## MERIDIAN STORAGE

FALCON RANCHETTES FILING NO. 1A, NORTH HALF OF THE SOUTHEAST QUARTER OF SECTION 1 TOWNSHIP 13 SOUTH, RANGE 65 WEST OF THE 6TH P.M., COUNTY OF EL PASO STATE OF COLORADO, MERIDIAN ROAD & OWL PLACE

## **CONSTRUCTION DRAWINGS**

VR239 & SDP2336

OWL PLACE - PUBLIC 60' R.O.W. 25 MPH DESIGN SPEED (LOCAL) SCALE: 1"=30'

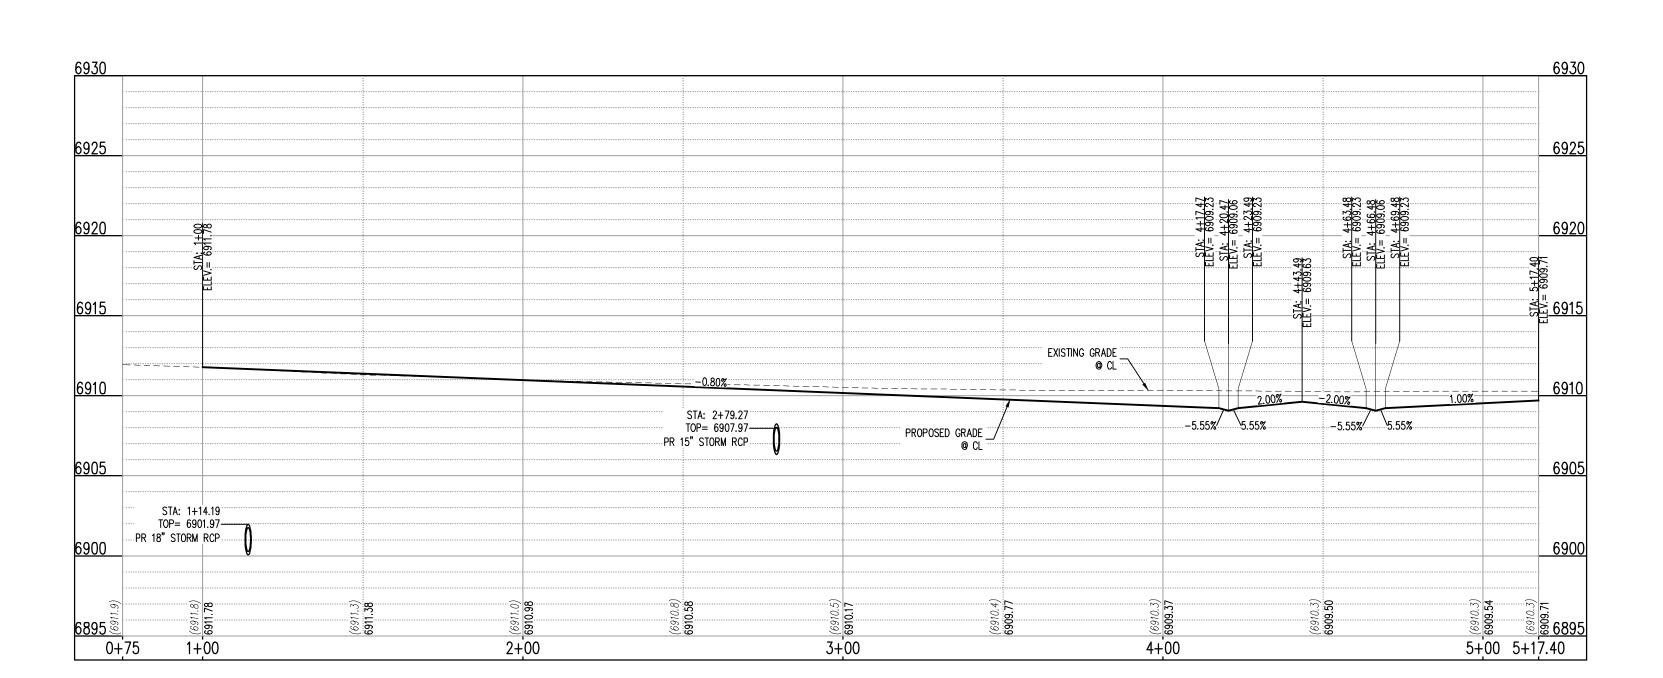
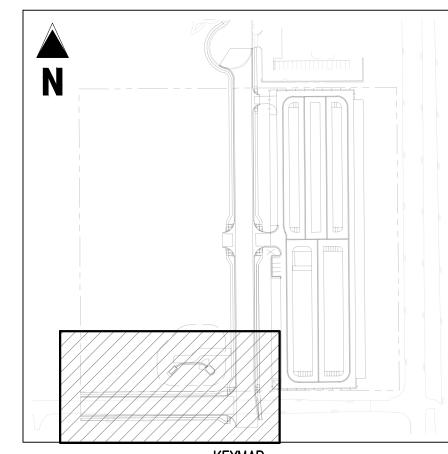
show proper justification for

STORM DRAIN PLAN - LINE A SCALE: 1"=30'

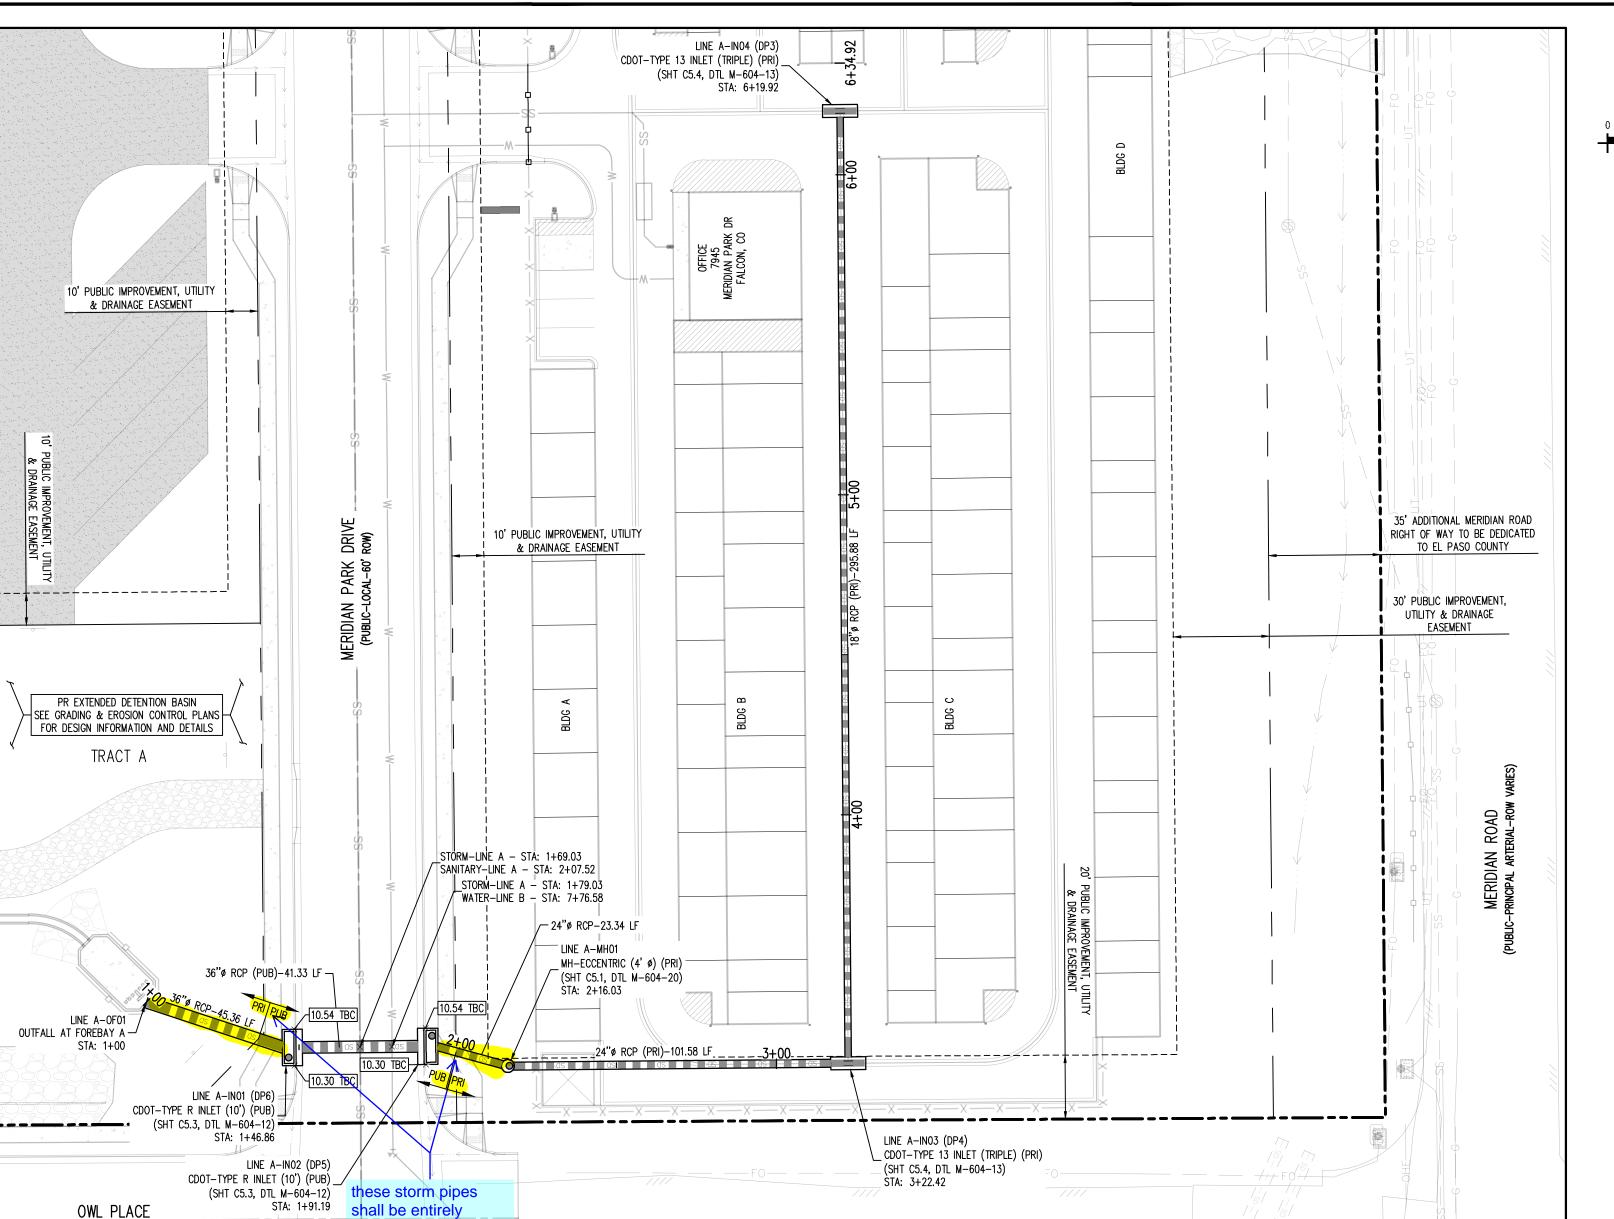
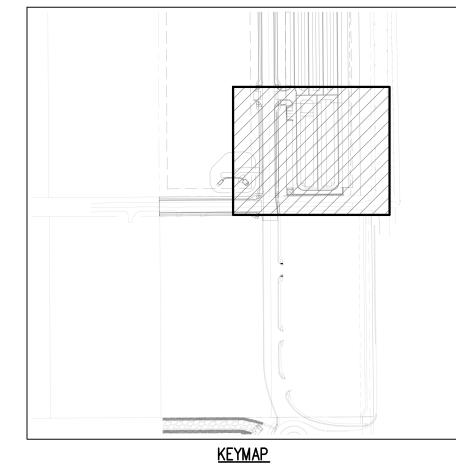
that they are private.Revise SCALE: 1"=30'
